Response to Comments for the Federal Register Notice for the Texas and Oklahoma Regional Haze State Implementation Plans; Interstate Visibility Transport State Implementation Plan to Address Pollution Affecting Visibility and Regional Haze; and Federal Implementation Plan for Regional Haze

Docket No. EPA-R06-OAR-2014-0754

12/9/2015

**Observed and predicted W20% haze index values for Guadalupe Mountains.
(Figure 3 of Alpine (0078))**

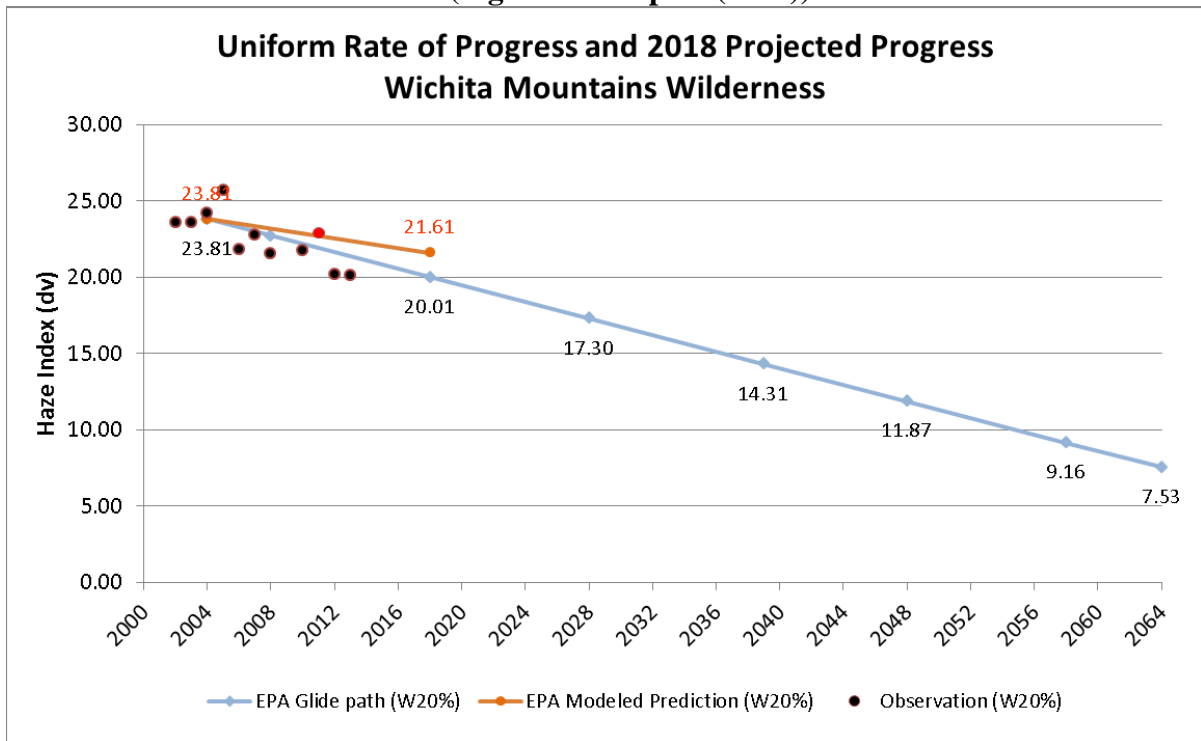
Alpine provided Figures 2 through 4 in Alpine comment 0078, showing these impacted W20% observation calculations are highlighted as red dots in 2011 and 2013.

Shown in Table 1 and Figures 2 through 4 of comment 0078, recent observations (black dots in Figures 1, 2, and 3) from these Class I areas indicate significant progress during the W20% days

Wildfire impact adjusted W20% haze index values for Big Bend National Park. (Figure 9 of Alpine (0078))

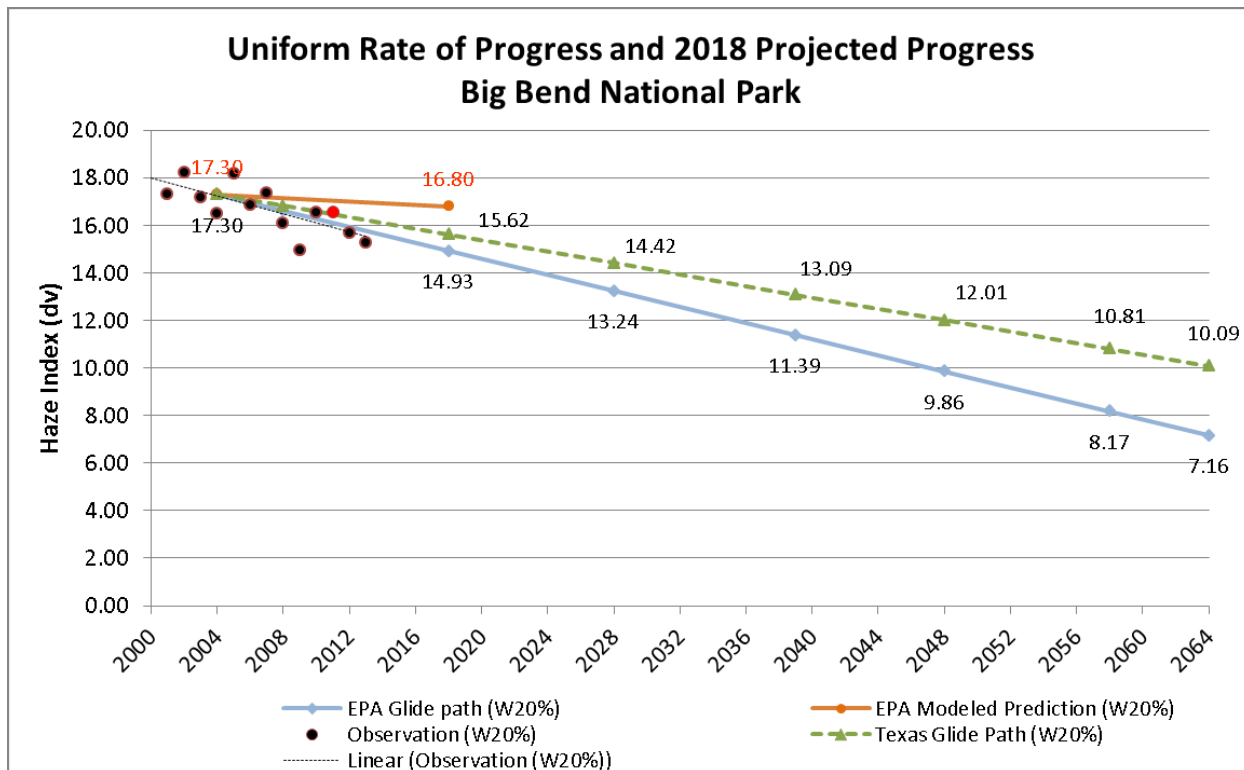
Alpine stated that when these wildfire impact days are removed from the W20% calculation, it can be seen in Alpine Figure 9 that the observational trend line would fall well below the EPA uniform rate of progress line.

Dust impact adjusted W20% haze index values for Guadalupe Mountains. (Figure 12 of Alpine (0078))

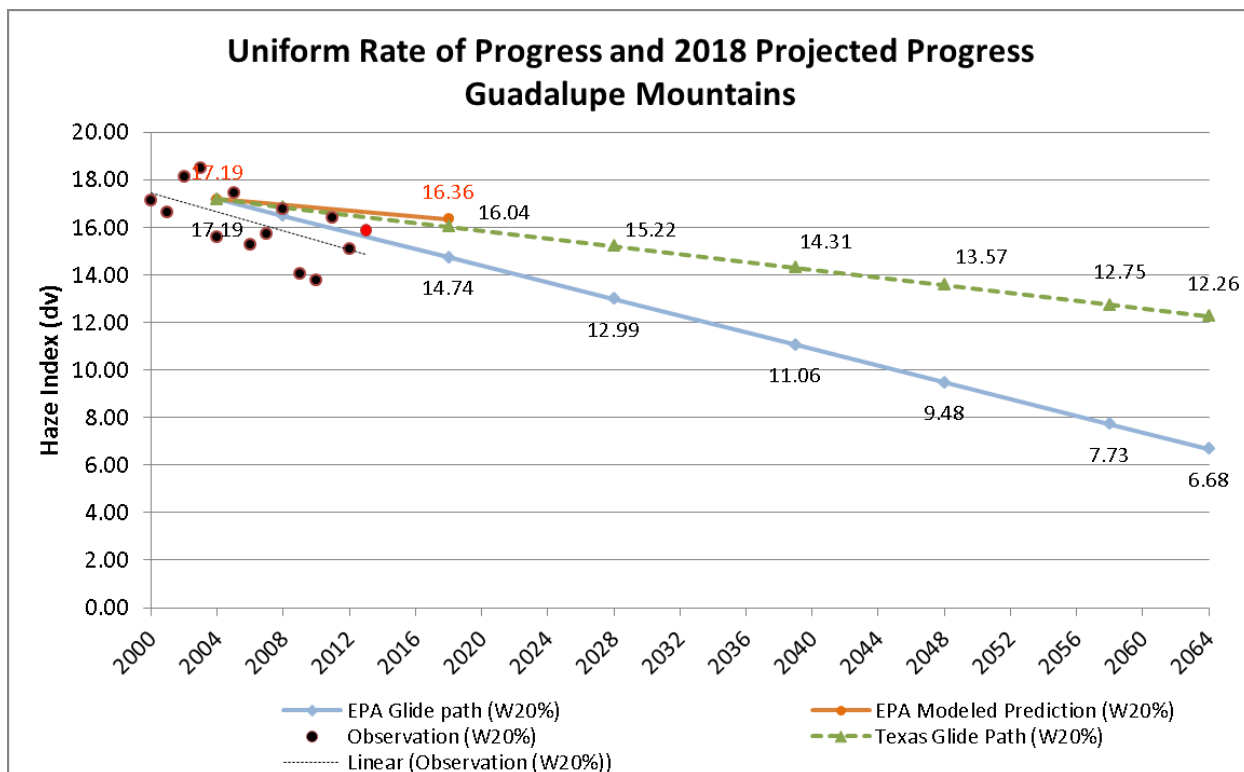
Alpine stated that in 2013 as documented in other years, dust event impacts have been tied to daily observations Class I areas in Texas.⁴ When removing dust impacted days from the W20% calculations, there are visibility trend improvement results comparable to years when wildfire impacts are removed, as shown in Alpine Table 4 and Figures 9 and 12 of comment 0078).
